TB-20-799

**RCRBD Record Set
T.A.**

A NEW PLAN FOR THE
HOME RANCH
27315 HOME RANCH ROAD
ROUTT COUNTY, COLORADO

COLUMBINE CABIN

SCALE: 3/4" = 1'-0"

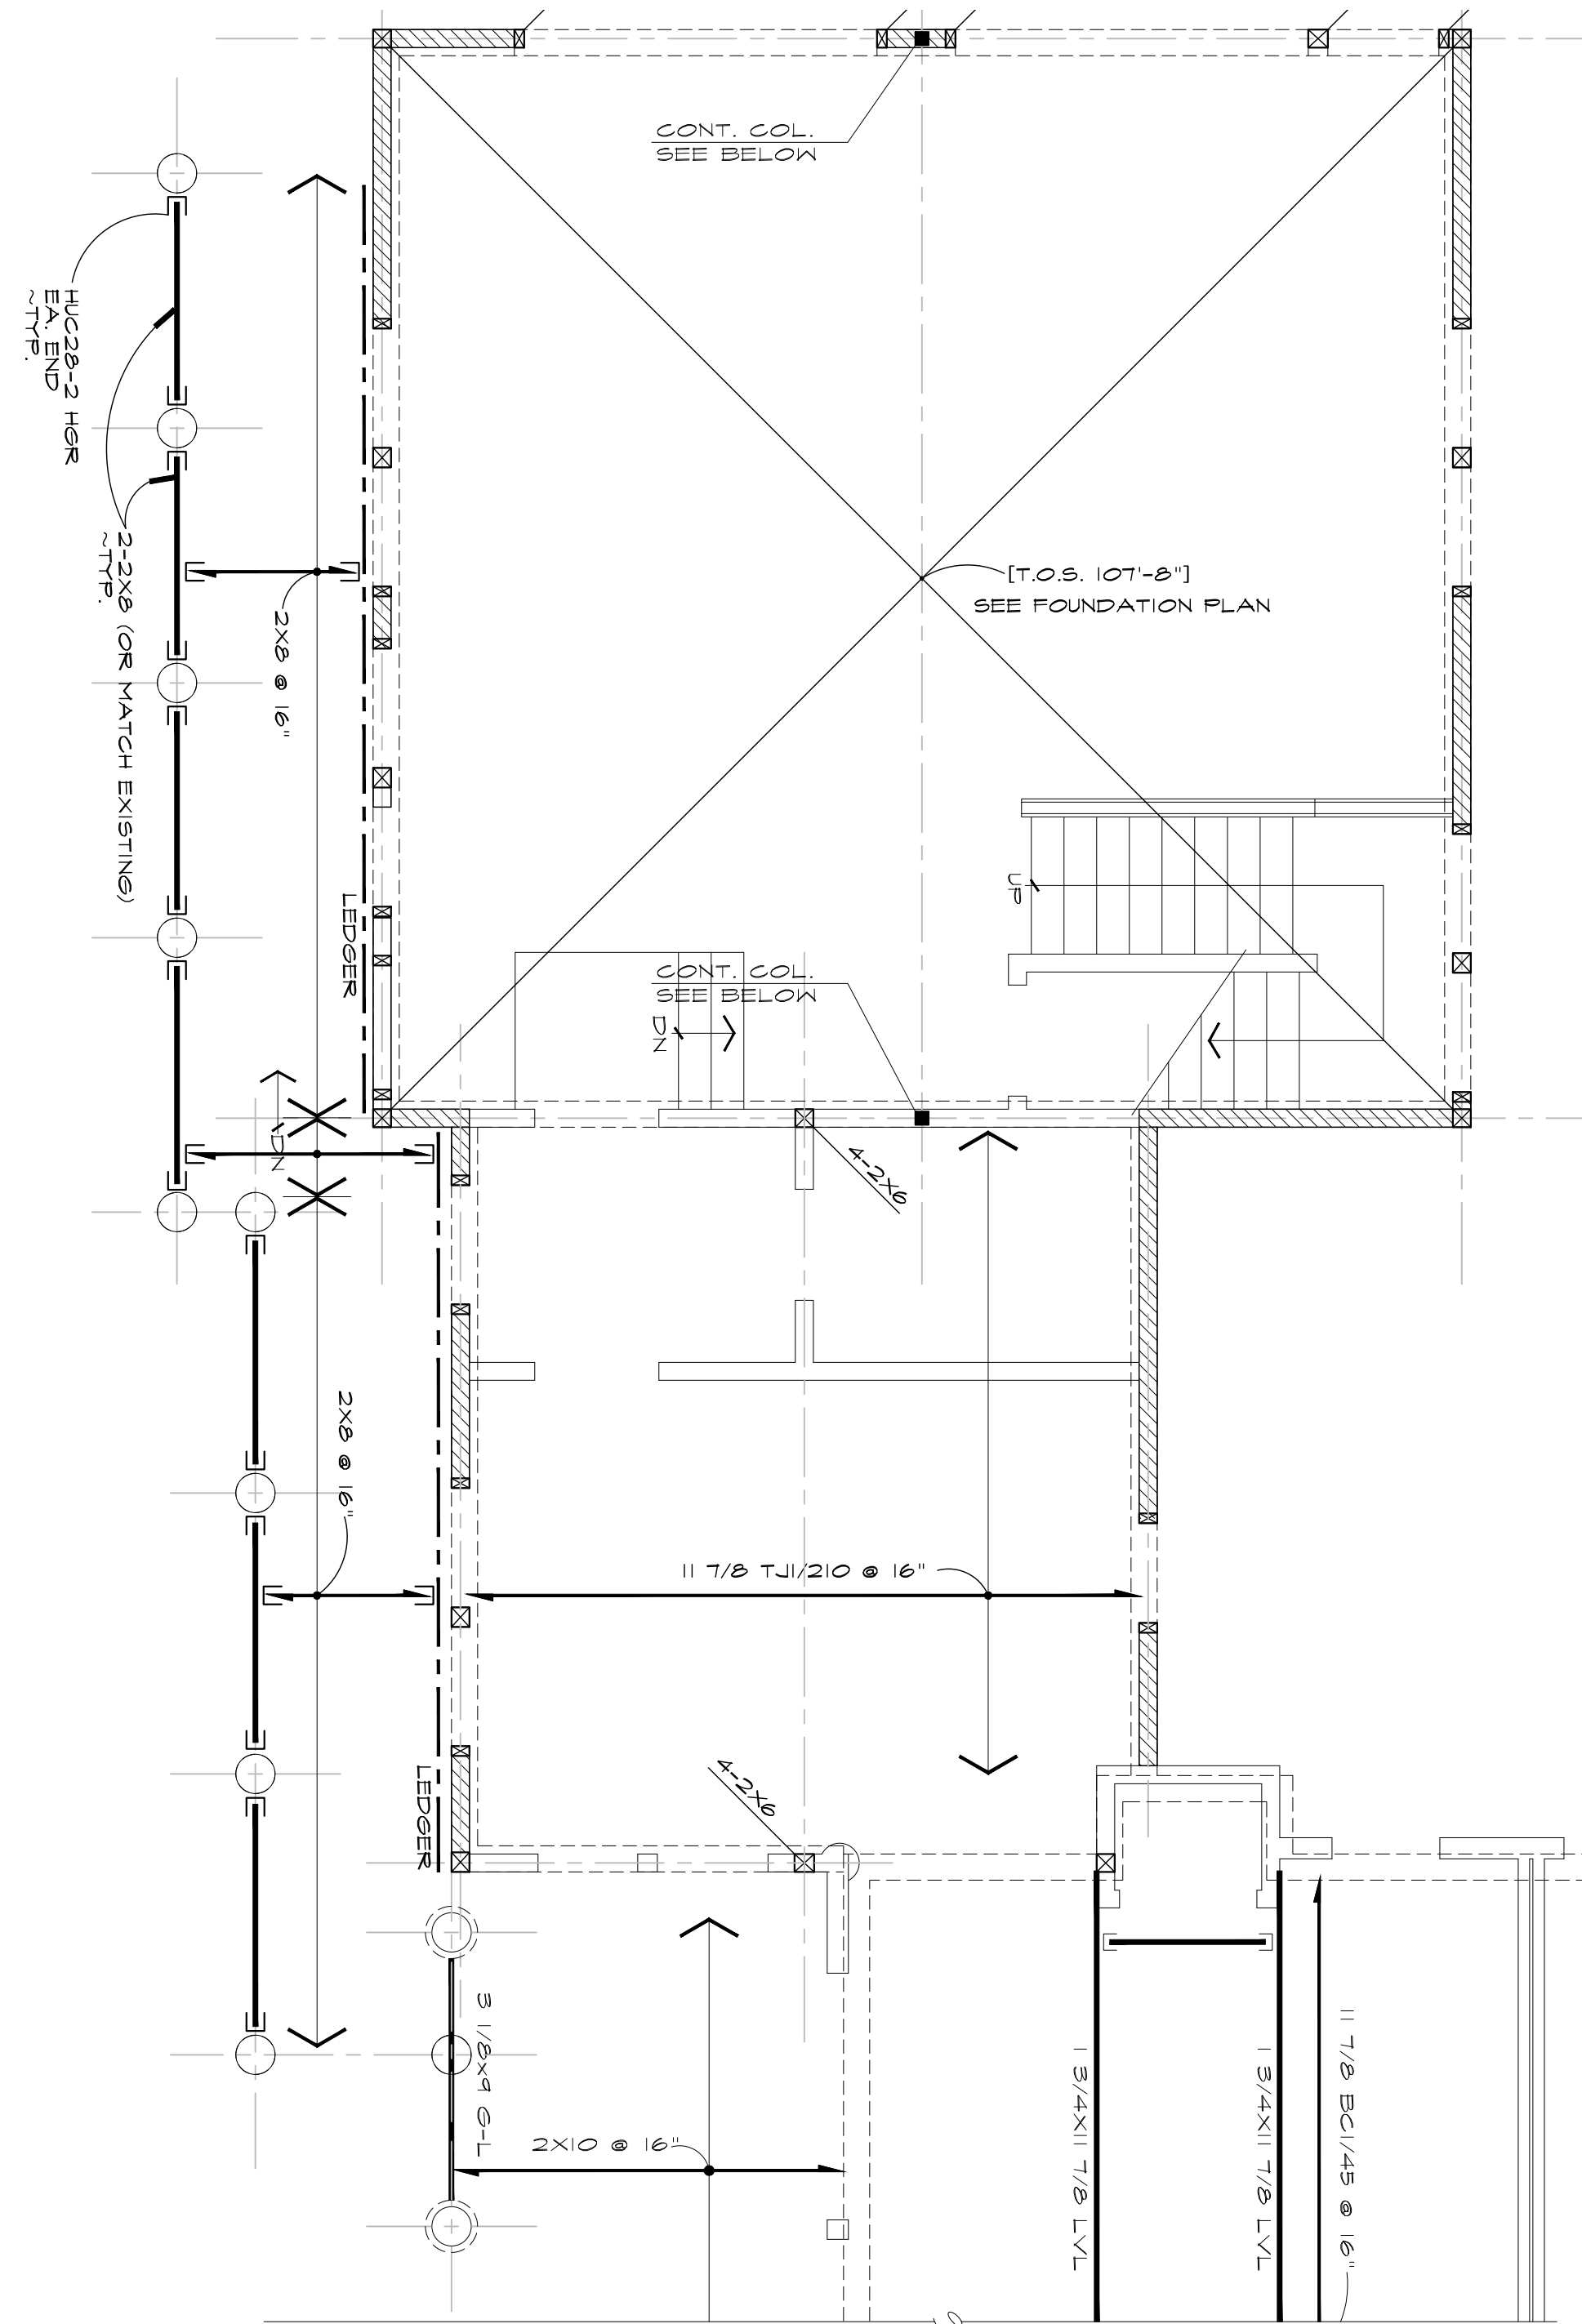
1. This project is in the concurrent review process with the other Departments. Review comments in Viewpermit, as applicable, when available.
2. The insulation value of walls provided under paragraph B of DIVISION 7 - THERMAL AND MOISTURE PROTECTION shows R-21 while the Table PRESCRIPTIVE PATH METHOD TO BE USED FOR I.E.C.C. COMPLIANCE provides the correct R-20 +5 continuous. Please show how this is installed in the wall and show how the conditioned crawl space is insulated.

SECTION 5 TYPICAL AT NEW CRAWL SPACE

SECTION 4 TYPICAL AT NEW STACKED LOG WALLS

We are submitting additional sheet number S-1.3 to clarify insulation requirements for the Columbine Cabin addition as requested in your plan review comments.
